TECHNICAL ADVISORY COMMITTEE REPORT

FILE NUMBER: 24-DP-24

SUBJECT: Preliminary Site Plan review for an approximately 2,490 SF Warehouse Building

WAREHOUSE METAL BUILDING
 6013 RODMAN STREET
 HOLLYWOOD, FL 33023

DRAWN	M.J.G.
CHECKED	D.J.A.
DATE	JULY, 2022
SCALE	AS NOTED
JOB. NO.	22-005
A-1.0	
OF SHEETS

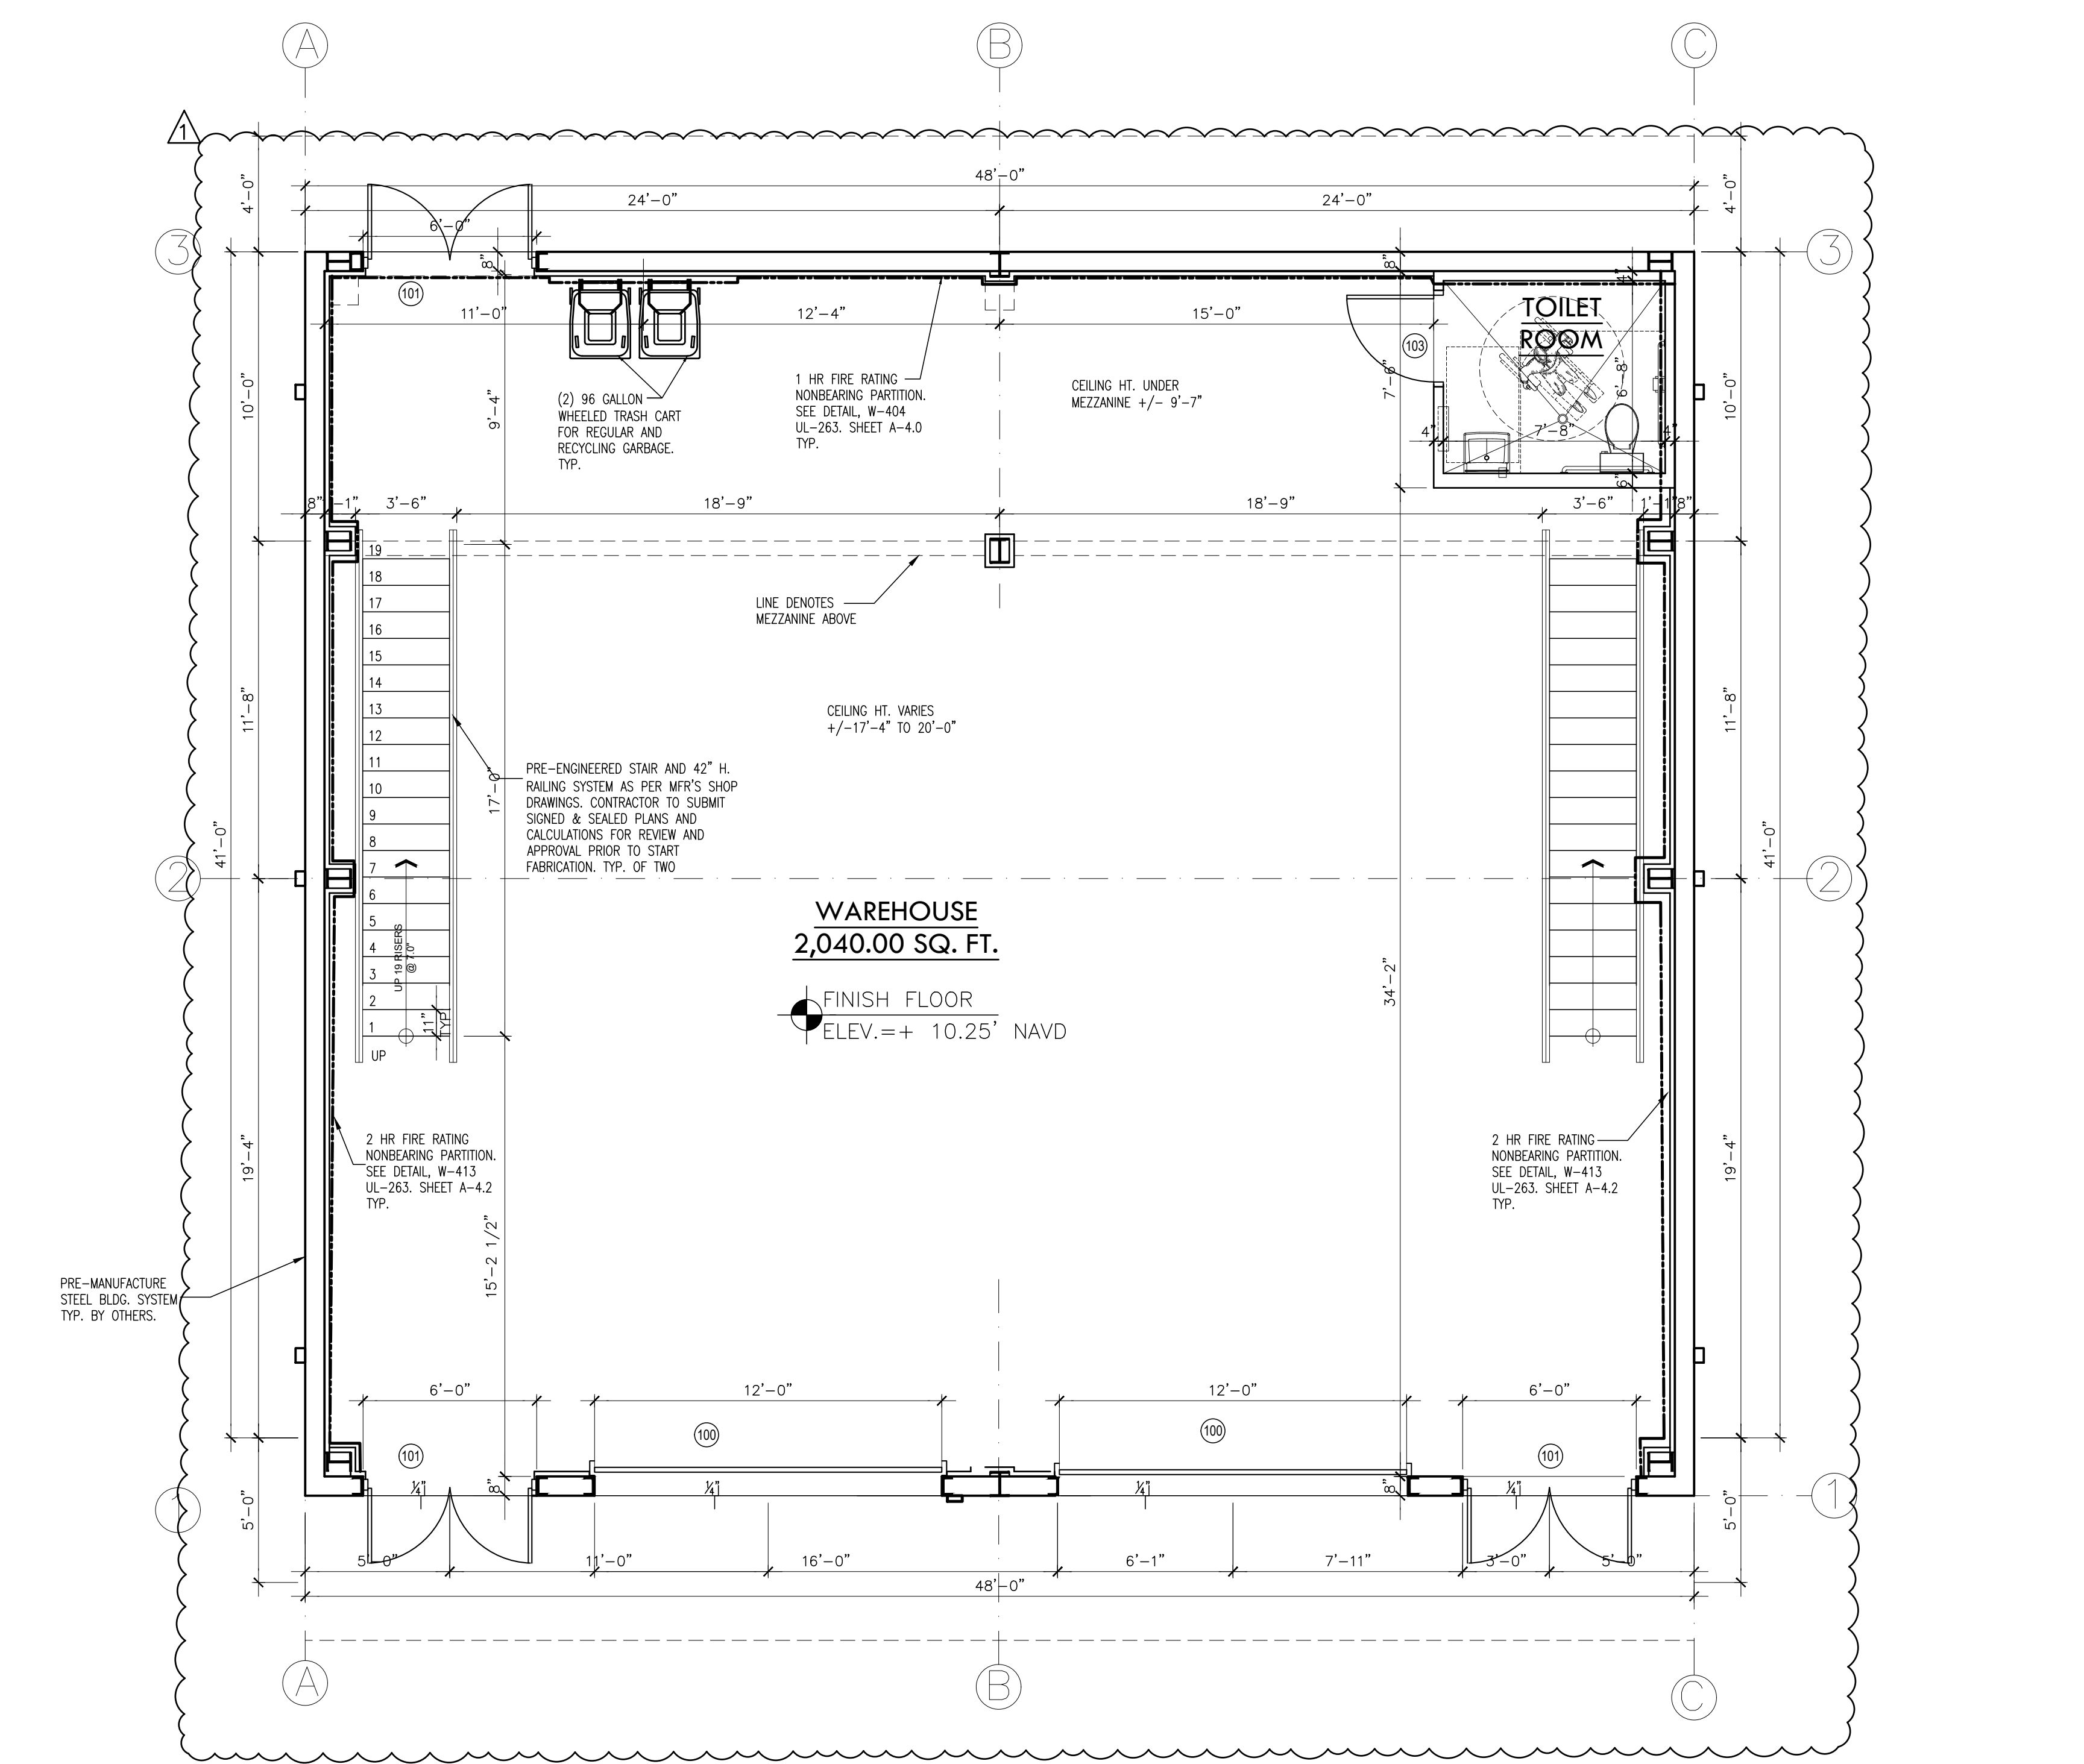
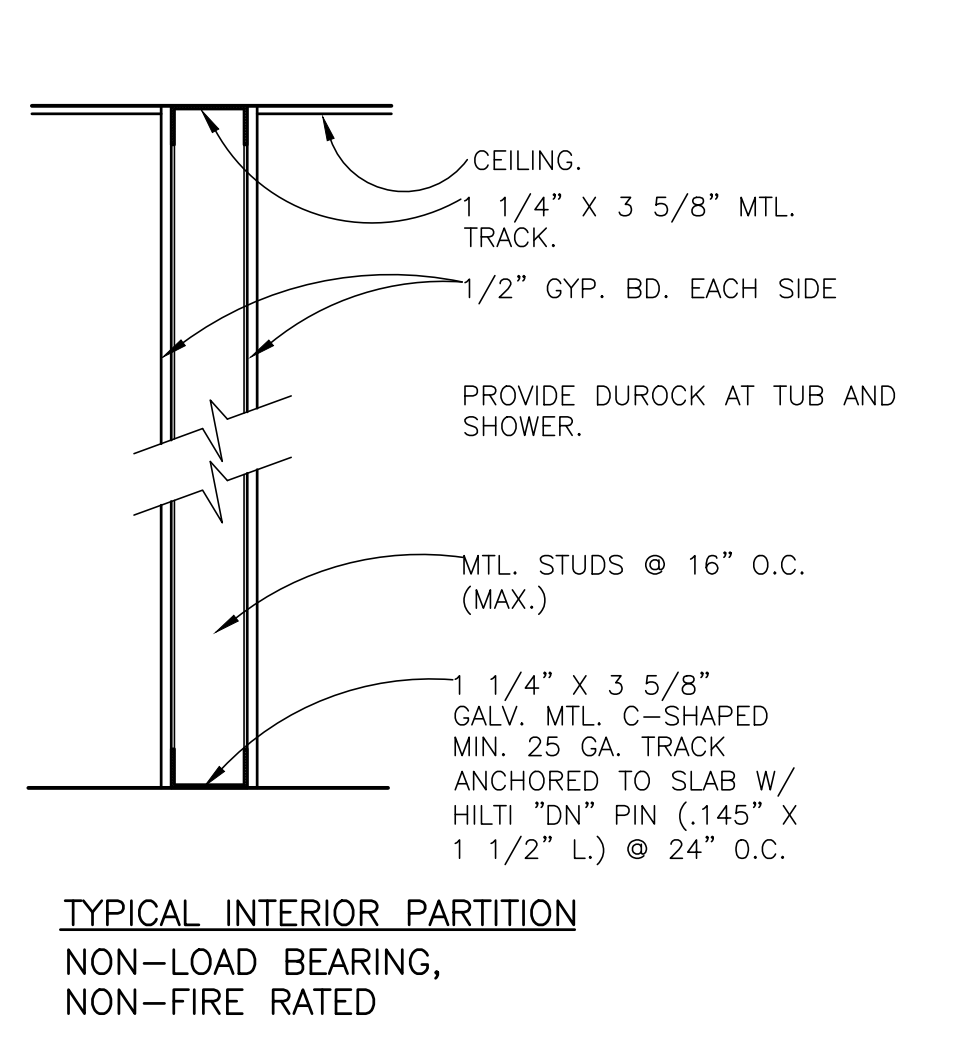
10. Indicate location on the site plan for garbage storage. Will a dumpster be provided for garbage as well as for recycle materials? Show how garbage is proposed to be picked up. **GARBAGE AND RECYCLE MATERIAL WILL BE STORAGE INSIDE THE BUILDING AND ROLL OUT TO THE OUTSIDE OF THE BUILDING THE PICK UP DAY, PLEASE SEE FLOOR PLAN FOR LOCATION ON SHEET A-1.0**

16. Be sure building square footage is consistent throughout, discrepancies exist between Sheet SP-1 and Sheet A-1.0. **PLEASE SEE REVISED SP-1 AND A-1.0**
